TRANSMITTAL OF VARIANCES TO PROJECT SPECIFIC PLANS

VARIANCE / FIELD CHANGE NOTICE

WBS NO.: PROJECT/DOCUMENT 20.03.13.06, ECDC #20300-PSP-0004 Rev1.

PROJECT TITLE: PSP for Excavation Characterization for Inactive Flyash Pile and SP5

FIGURE 2-2. ACRES IDENTIFIE OR THE PRE-CERTIFICATION PHASE I SCAN

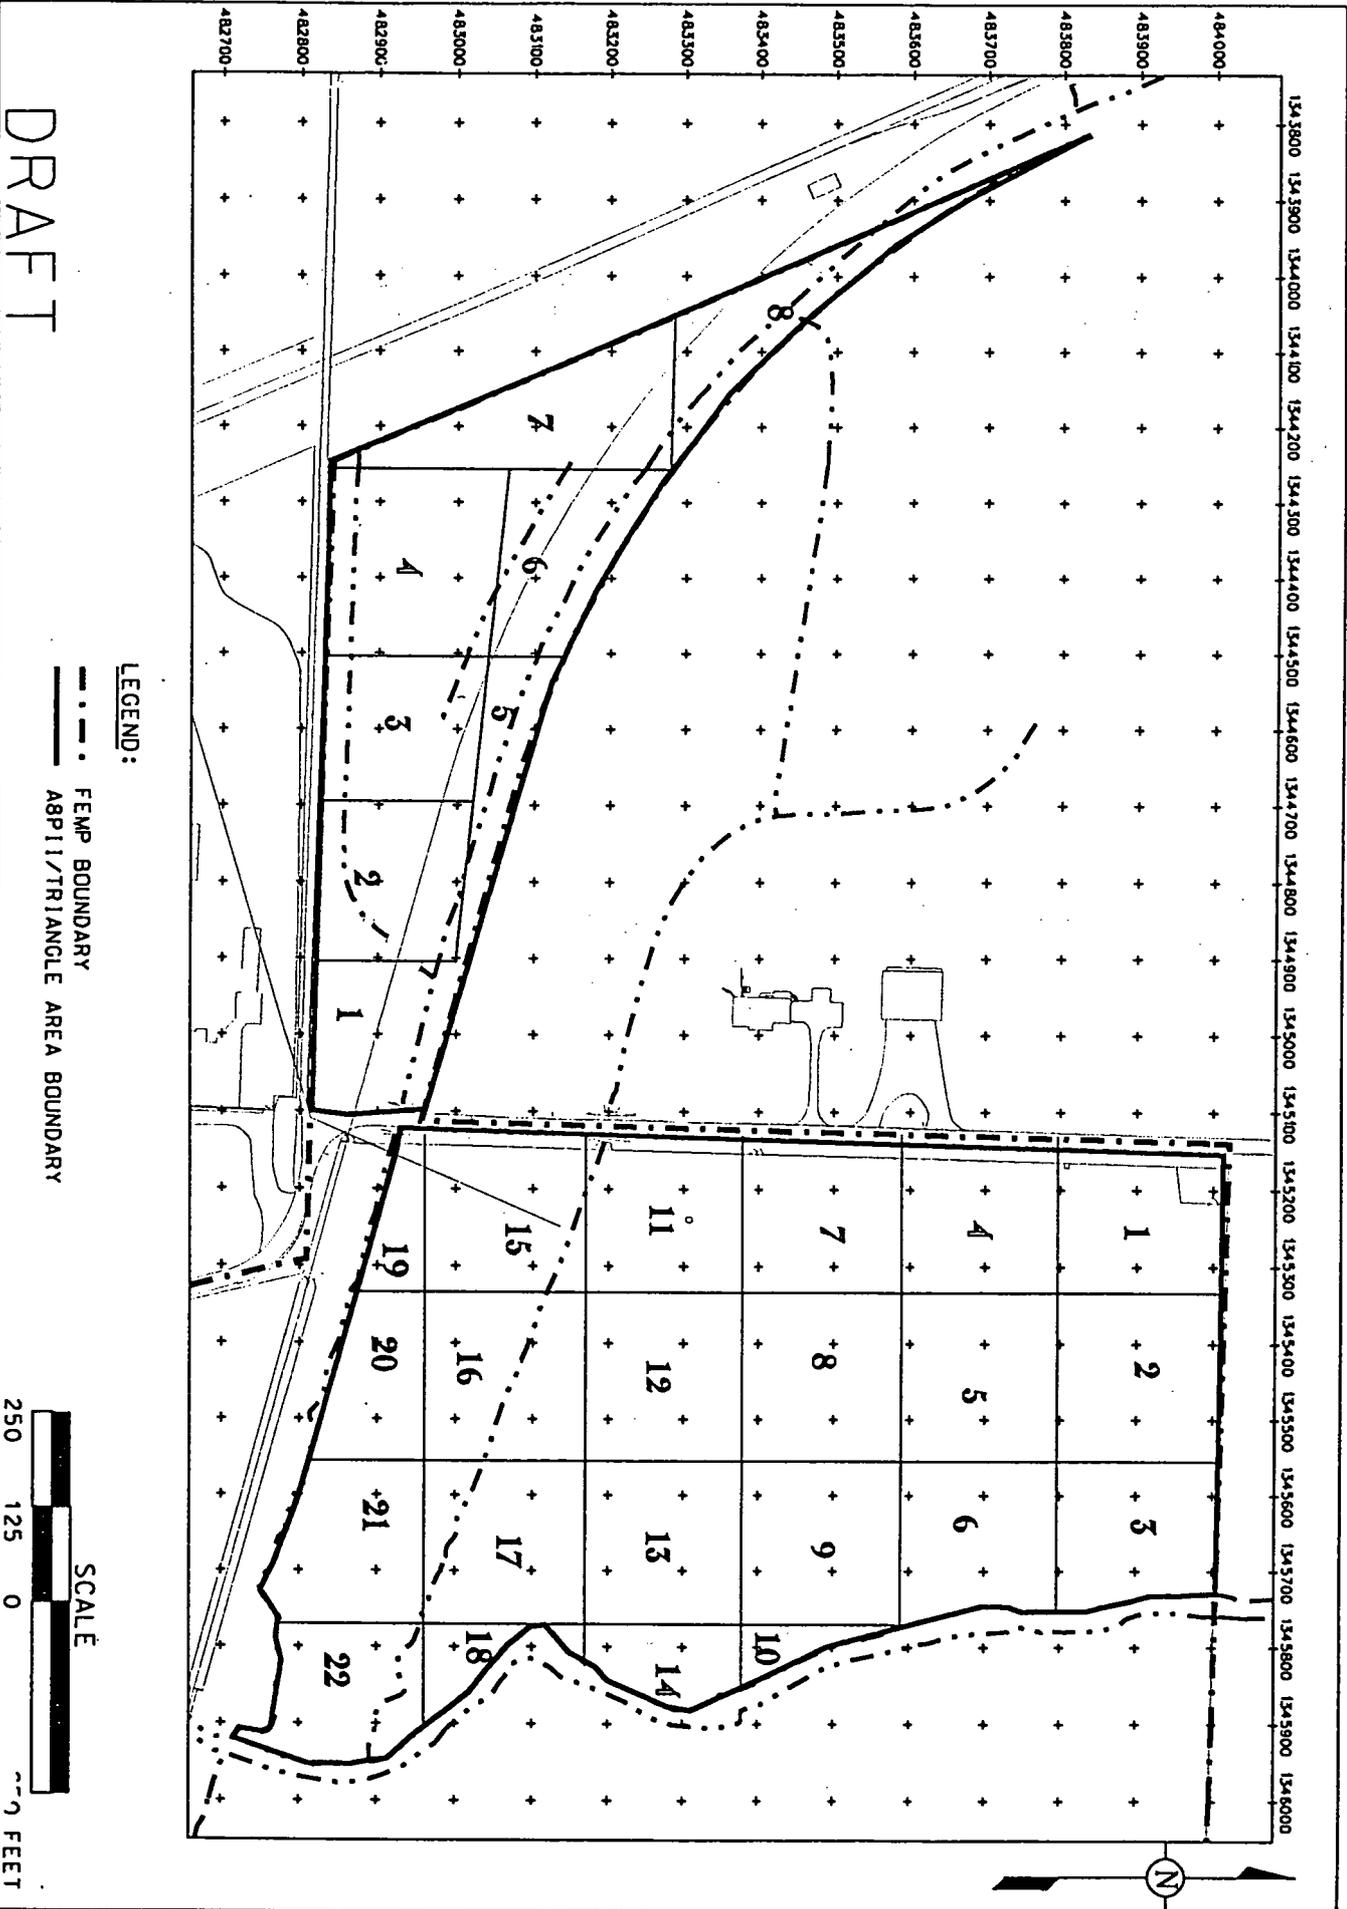
- 1) Per Section 2.4 of the PSP, this V/FCN documents the numbered acres that have been delineated in A8P11 and the Triangle Area (see attached Figure 2-2).
- 2) The radon measurements will be numbered as follows:
Area-Precertification Phase-Purpose-Height-Reading #, where:
 Area = "A8P2" or "A6TA"
 Precertification Phase = "P1" or "P2"
 Purpose = "Radon"
 Height = "1" = 15 cm, "2" = 31 cm, "3" = 1 meter
 Reading # = Sequential number
 For example, the third sequential radon measurement, obtained during Precertification Phase I from the Triangle area at the 31 cm height would be numbered as: **A6TA-P1-Radon-2-3**.

acre delineation is necessary to guide the real-time data collection approach and to verify the Phase 1 readings. The radon numbering system was not identified in the PSP, and is necessary to tie the readings back to the appropriate real-time measurements.
